TITEL: Justering av varvtalsregulatorns minimumstopp (Ground Idle)

GÄLLER: MU-2B modeller och S/N angivna i bifogad kopia av FAA AD 94-11-04.

AIRWORTHINESS DIRECTIVE

94-11-04 MITSUBISHI HEAVY INDUSTRIES, LTD.: Amendment 39-8920; Docket No. 94-CE-09-AD.

FIGURE 1

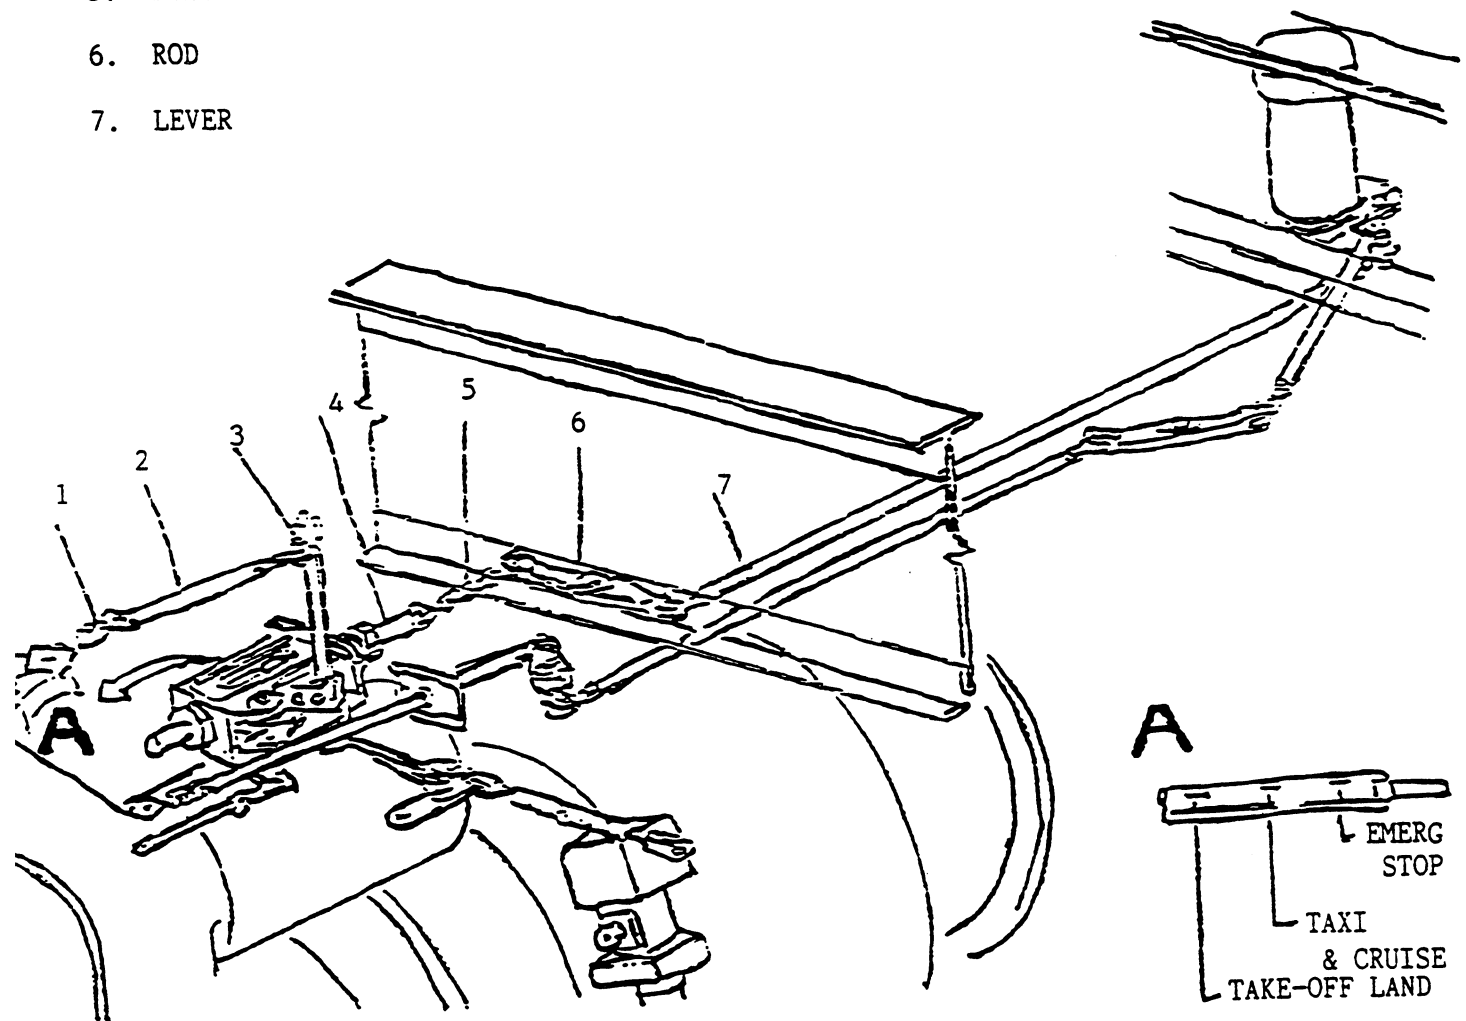
(b) Modify the airframe condition control linkage by adjusting Rod 1 and Levers 2 and 7 as specified in Figure 1 of this AD in accordance with Chapter 6, Section 9.2, of the applicable Mitsubishi MU-2 maintenance manual.

1. ROD
2. LEVER
3. CYLINDER ASSEMBLY
4. ROD (Reference dimension 3.39 inches \pm by 0.02 inches)
5. BELL CRANK
6. ROD
7. LEVER

Figure 2

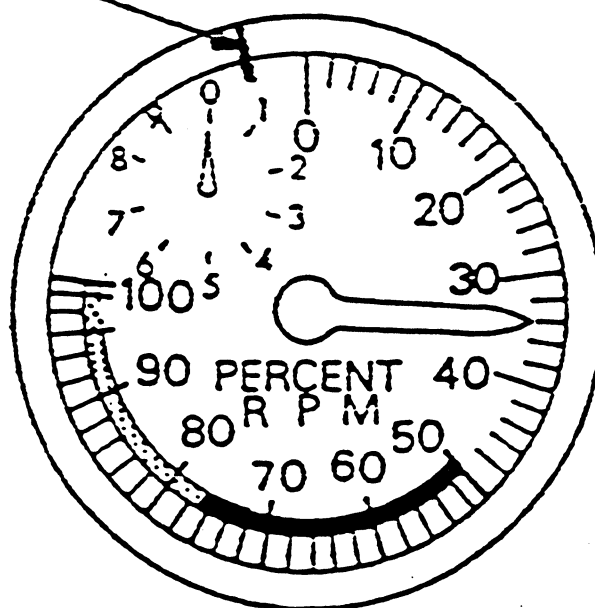
(2) Using white lacquer (MIL-L-7178, color number 511 or equivalent), apply a 1/16-inch wide by 1/4-inch long slip stripe over the tachometer glass and indicator case at the 11:30 o'clock position as specified in Figure 2 of this AD.
